Your ref: Docket No. 52-006  
Our ref: DCP/NRC1631

**SUBJECT: Transmittal of Responses to AP1000 DSER Open Items**

## Draft Safety Evaluation Report Open Item Response

Figure 15.2.7-1 DEDVI: Intact IRWST Injection Flow

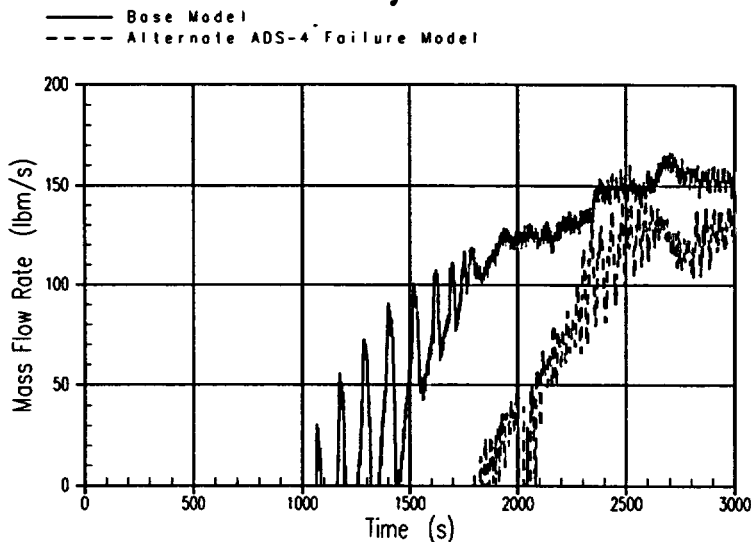
Tests at the AP1000 APEX facility indicate that the single failure of a stage 4-ADS valve produces lower core inventories if the failed valve is not in the pressurizer loop. The revised DCD Section 15.6.5.4C.2 (DSER OI 15.2.7-1P Page 14) states that the analysis of the DEDVI LTC case assumes failure of one of the two ADS-4 valves in the PRHR loop. Since the PRHR loop is the same loop that contains the pressurizer, justify that the small break analyses in Chapter 15 of the DCD are conservative in view of the test results from the APEX facility.

As was observed in the AP1000 APEX facility, the ADS Stage 4 valve failure on the non-pressurizer side (ADS 4-1) resulted in a delay in the onset of IRWST injection flow (Figure 15.2.7-1). This can also be observed in the intact DVI line injection line flow as well (Figure 15.2.7-2). However, as observed in the AP1000 APEX simulations, the effect on the core/upper plenum two-phase mixture is minimal (Figure 15.2.7-3) with significant margin to core uncover being observed.

With the assumed failure in the ADS 4-1 path, RCS depressurization is slowed (Figure 15.2.7-13) and IRWST injection is delayed (Figure 15.2.7-1); however, the vessel inventory is only minimally altered (Figure 15.2.7-6). A review of the pressurizer inventory (Figure 15.2.7-14) indicates that the initial decrease in ADS 4-1 discharge can be attributed to a combination of the failure assumption in the ADS 4-1 path and the mass storage differences in the pressurizer. This pressurizer mass storage behavior was also observed in the AP1000 APEX tests. The difference in pressurizer mass dominates until IRWST injection begins at which time excess inventory is discharged via the ADS 4 paths (Figure 15.2.7-9). No significant change in ADS-4 vapor discharge is observed between the two simulations (Figure 15.2.7-15).

Figure 1: Containment Backpressure for DEDVI

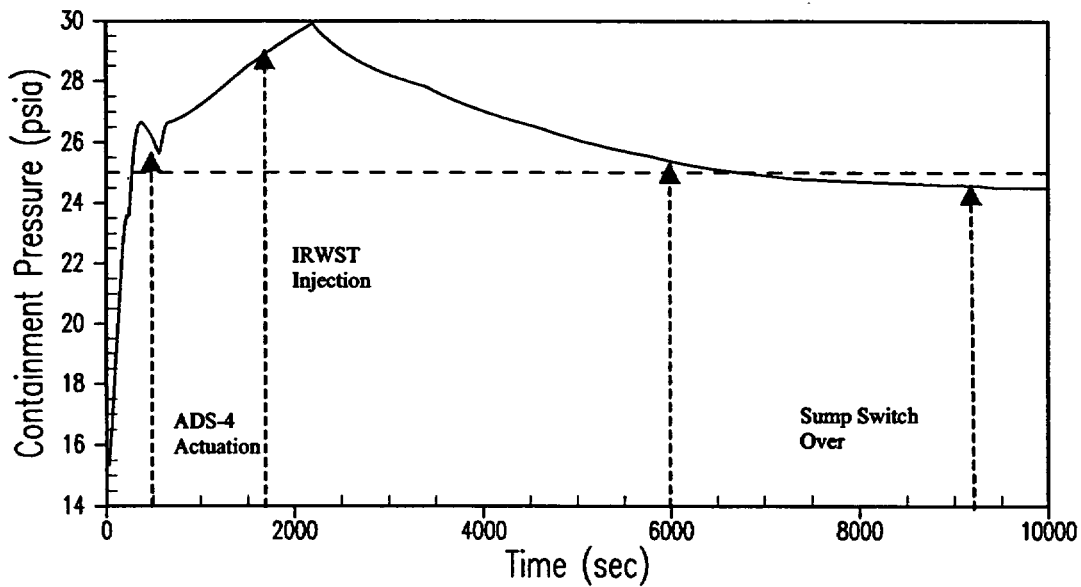
The revised DCD Section 15.6.5.4C (DSER OI 15.2.7-1P Page 14) states that the LTC phase analysis uses the NOTRUMP DEDVI case at 25 psia containment pressure reported in Section 15.6.5.4B as initial conditions, and the WGOETHIC analysis of this event as boundary conditions.

The containment pressure for this event is shown in Figure 1. Also shown are the times for ADS-4 actuation, IRWST actuation and switch over to sump recirculation. This figure shows that 25 psia is an acceptable backpressure for the DEDVI LOCA analysis for the time period following the initial blowdown until the initiation of sump injection. For the first 200 seconds, the pressure is below 25 psia, but during this time, the RCS pressure is high and the containment backpressure has little effect on the plant response. At the time of IRWST injection, the backpressure is well above 25 psia. As the IRWST drains, the pressure continues to fall reaching approximately 24.5 psia at sump recirculation. Thus, for the short-term analysis, the backpressure of 25 psia is a conservative limit. A lower pressure boundary condition is appropriate for times after sump recirculation is established.

Figure 21.5-1.12 ADS-4 Liquid Discharge Comparison

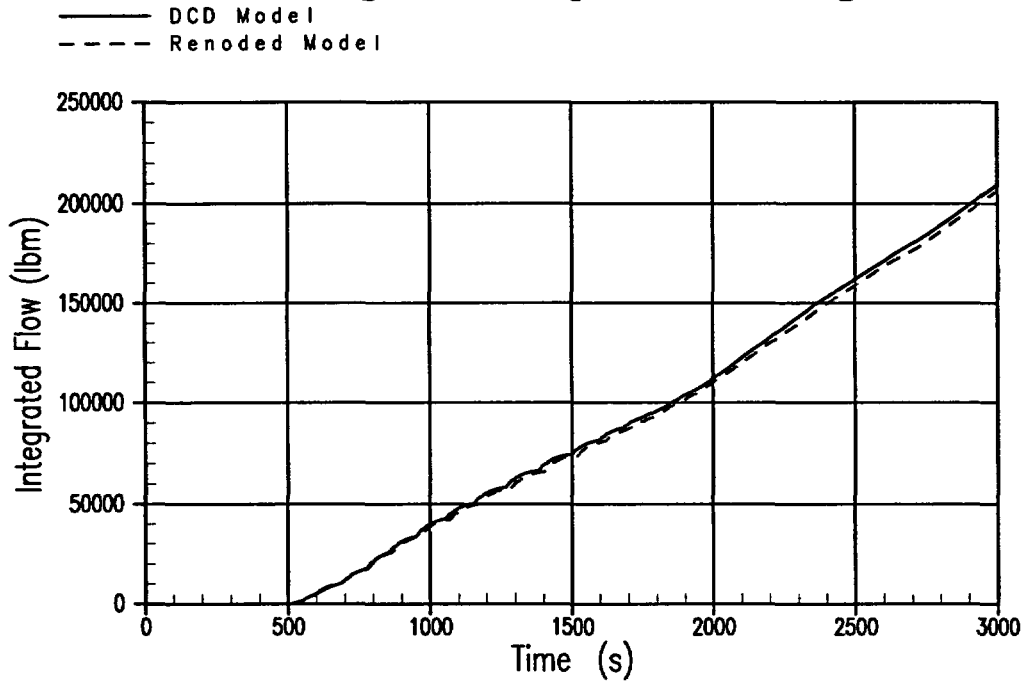
For the comparison of the integrated liquid discharge through ADS-4 between the base DCD case and the revised nodding model, Figure 21.5-1.12 on DSER OI 21.5-1P Page 11 has an inconsistency in that the heading states "ADS-4 Liquid Discharge Comparison" whereas the actual figure is for ADS-4 integrated vapor discharge.

Please clarify.

Figure 21.2.1-12 was intended to be a plot of ADS-4 Liquid Discharge Comparison. However the figure that was included was ADS-4 integrated vapor discharge as the Item states. The attached figure is the corrected Figure 21.5-1.12 that shows ADS-4 Liquid Discharge Comparison.

Figure 21.5-1.14 Downcomer Pressure Comparison

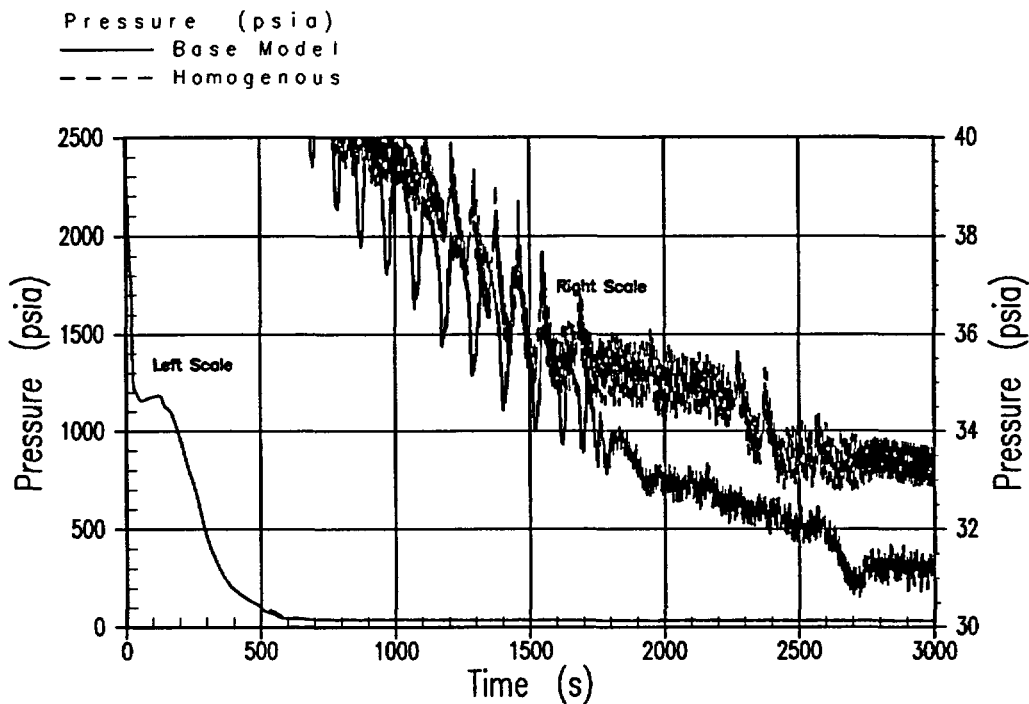
The text on DSER OI 21.5-1P Page 3 states that Figure 21.5-1.14 presents a comparison of the upper downcomer pressure between the base case and the sensitivity case, but the actual figure is for pressurizer pressure (except for the heading). The text also states that the pressurizer mixture level response (Figure 21.5-1.25) reflects the change in pressure response (Figure 21.5-1.14) observed in the model.

Clarify the discrepancy regarding Figure 21.5-1.14.

Figure 21.5-1.14 was intended to show the upper downcomer pressure between the base case and the sensitivity case, but the actual figure is incorrect as stated in Item 17 above. The attached figure provides the corrected Figure 21.5-1.14. The plot of Pressurizer pressure is also provided as 21.5-1.26 and the text should refer to this figure for pressurizer pressure. No update to the previous response is intended.

Figure 21.5-2.I24-1 AP1000: Core Upper Plenum Two-Phase Mixture Level

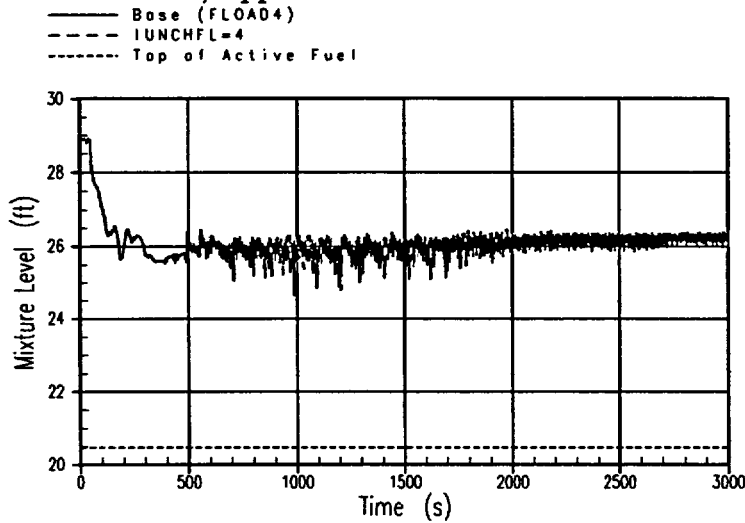
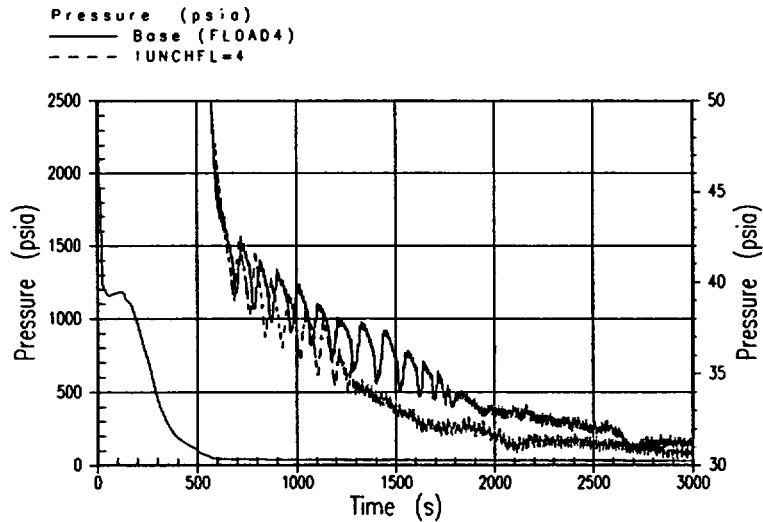
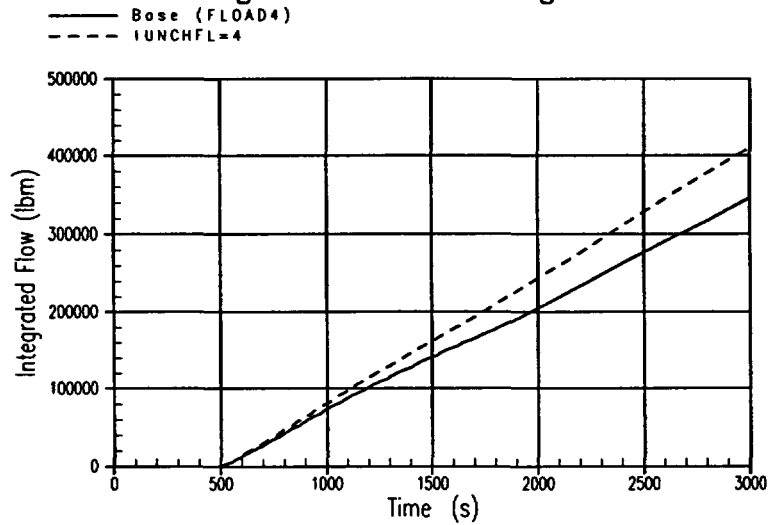
It is noted that several different NOTRUMP model approaches are used in the NOTRUMP simulation of the APEX-1000 tests compared to the AP1000 small break LOCA DBA analysis. These include revised noding in the pressurizer, revised noding in the core makeup tank, no PRHR heat transfer area adjustment is applied, use of different ADS critical and non-critical flow models, and use of a break flow multiplier to more accurately represent the results observed in the test.

Please provide a complete list of all differences of the NOTRUMP model between the APEX-1000 simulation and AP1000 plant analyses, and justify why the test simulation conclusions can be applied to the NOTRUMP models used for the AP1000 analysis.

As described in Section 1.16 of Reference 1, the basic reactor coolant system (RCS) noding utilized is an evolution of the standard plant NOTRUMP Evaluation Model (EM). Specific noding was added for the passive safety system components, such as the passive residual heat removal (PRHR) heat exchanger, core makeup tanks (CMTs), in-containment refueling water storage tank (IRWST), and automatic depressurization systems (ADS). The noding bases for these individual components were generated by analysis of individual separate effect tests (SET) for each component. The noding for the individual components obtained from the SETs was then applied to the integral effects test (IET) i.e., SPES-2 and Oregon State University (OSU), and eventually to the AP600/AP1000 plant models themselves.
